CLASS III SITE PLAN REVIEW

NEW BUILDING
FOR JOHNSON FAMILY
ORTHODONTICS

SITE PLAN – CLASS 3 & DRIVEWAY APPROACH PERMIT

**SUBJECT: PUBLIC WORKS RECOMMENDATIONS
SPR-ADJ-DAP 20-33 (20-106981-RP)
5669 COMMERCIAL STREET SE
OUTPATIENT MEDICAL FACILITY**

SHEET
A1.1

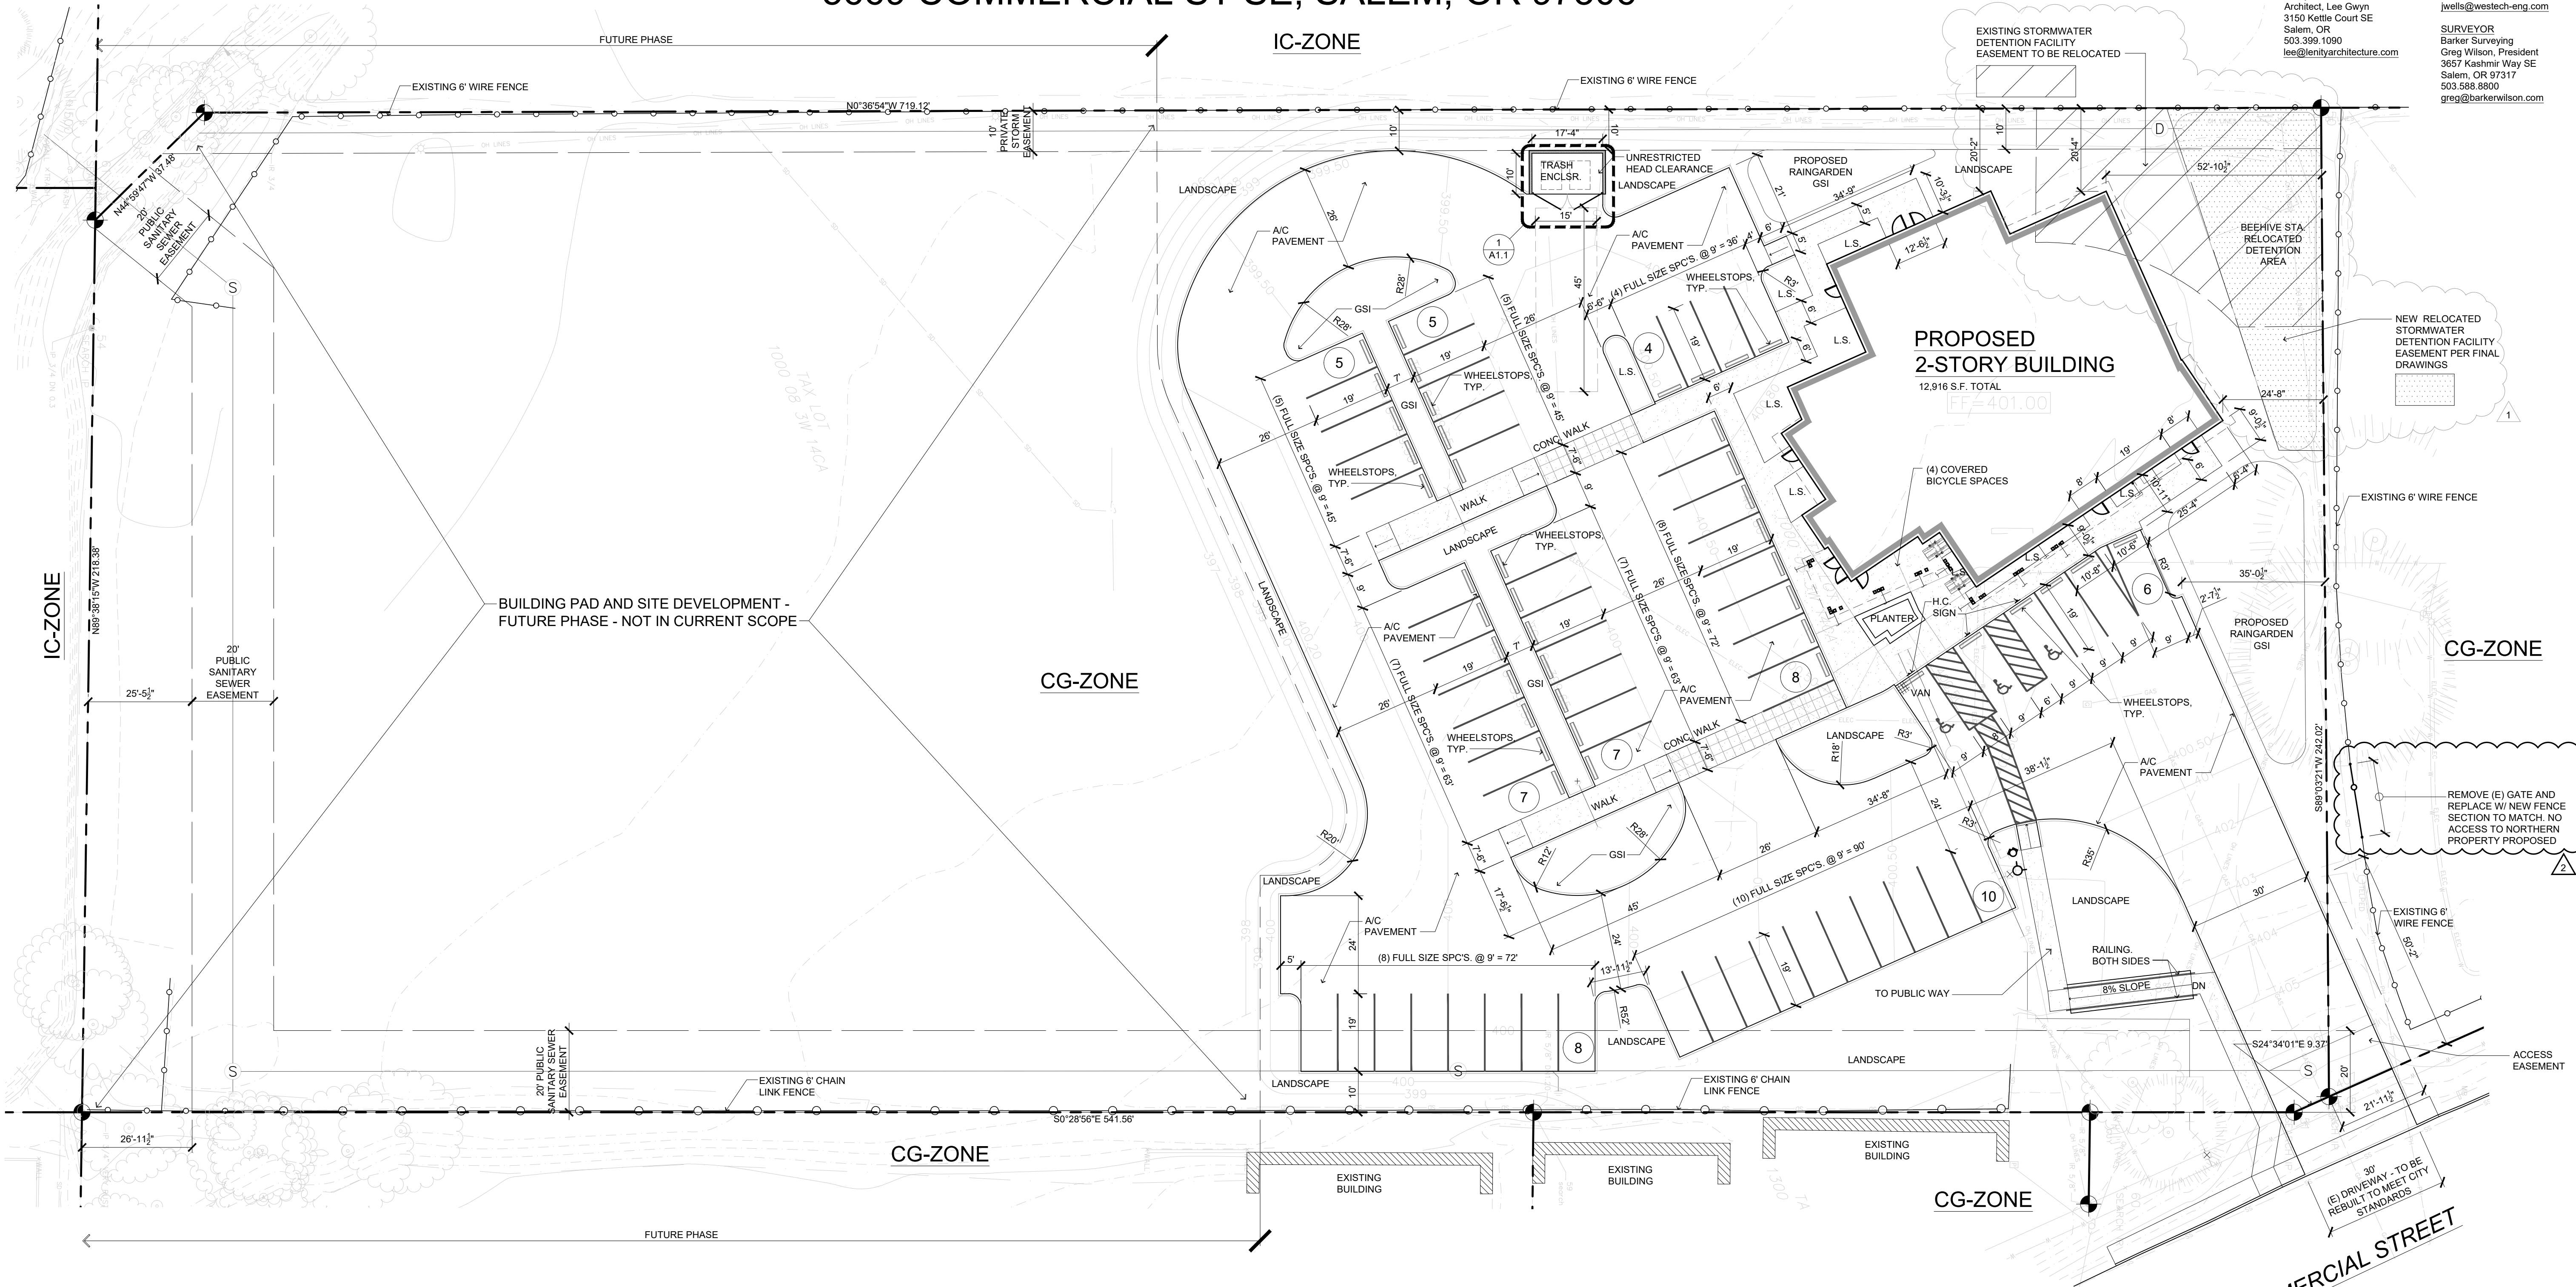
Finding—The existing configuration of Commercial Street SE does not meet current standards for its classification of street per the Salem TSP. The applicant shall construct a half-street improvement to Major Arterial street standards as specified in the PWDS and consistent with the provisions of SRC Chapter 803. Commercial Street SE is currently a turnpike section along the frontage of the subject property. Due to limited property frontage and construction limitations north and south of the property, the improvements are eligible for a fee-in-lieu of construction pursuant to SRC 200.405.

Finding—The proposed driveway access onto Commercial Street SE is shared with the adjacent property to the north and provides for safe turning movements into and out of the property.

Finding—The Public Works Department has reviewed the applicant's preliminary plan for this site. The water and storm infrastructure are available within surrounding streets/areas and are adequate to serve the proposed development. The applicant is proposing extension of an 8-inch public sewer main that is consistent with the *Salem Wastewater Management Master Plan*. The applicant shall construct the public sewer improvements to PWDS standards and dedicate pipeline easements in widths that conform with PWDS 1.8. An all-weather access road in conformance with PWDS is required for access and maintenance of the proposed public sewer manholes.

A private stormwater detention facility is located within an easement at the northwest corner of the subject property. This facility was designed and constructed to serve the northerly abutting property. No buildings or structures are allowed within this easement pursuant to PWDS and the terms of the easement. The site plan indicates the existing stormwater detention facility and easement will be modified to accommodate the proposed building footprint.

Finding—The proposed driveway is located less than 370 feet from adjacent driveways; therefore, a Class 2 adjustment is required for driveway spacing as described below. Otherwise, the proposed driveway meets the standards for SRC 804 and PWDS.

1. Construct a half-street improvement along the frontage of Commercial Street SE to Major Arterial street standards as specified in the City Street Design Standards and consistent with the provisions of SRC Chapter 803. This improvement is eligible for a fee-in-lieu of construction pursuant to SRC 200.405.
2. Provide an all-weather access road and easements pursuant to PWDS for the proposed 8-inch public sewer extension. The width of the public easements shall conform with PWDS 1.8.
3. Dedicate an open channel drainage easement along the portion of Waln Creek that is adjacent to the subject property. The easement width shall be either the 100-year floodway, 15 feet from the channel centerline, or 10 feet from the top of the recognized bank, whichever is greatest.
